**Economic and Social Council**Distr.: General
27 February 2014

Economic Commission for Europe**Inland Transport Committee****World Forum for Harmonization of Vehicle Regulations****Working Party on Passive Safety****Fifty-fifth session**

Proposal for a new Regulation on Pole Side Impact**Draft 01 series of amendments to the draft new Regulation
No. [X] concerning the approval of vehicles with regard to
their Pole Side Impact performance****Submitted by the expert from Australia ***

Model A
(See paragraph 4.5. of this Regulation)

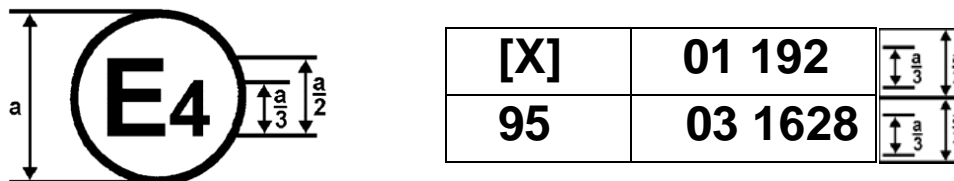
The above approval mark affixed to a vehicle shows that the vehicle type concerned has, with regard to its pole side impact performance, been approved in the Netherlands (E4) pursuant to Regulation No. [X] under approval number 01124. The approval number indicates that the approval was granted in accordance with the requirements of Regulation No. [X] as amended by the 01 series of amendments.
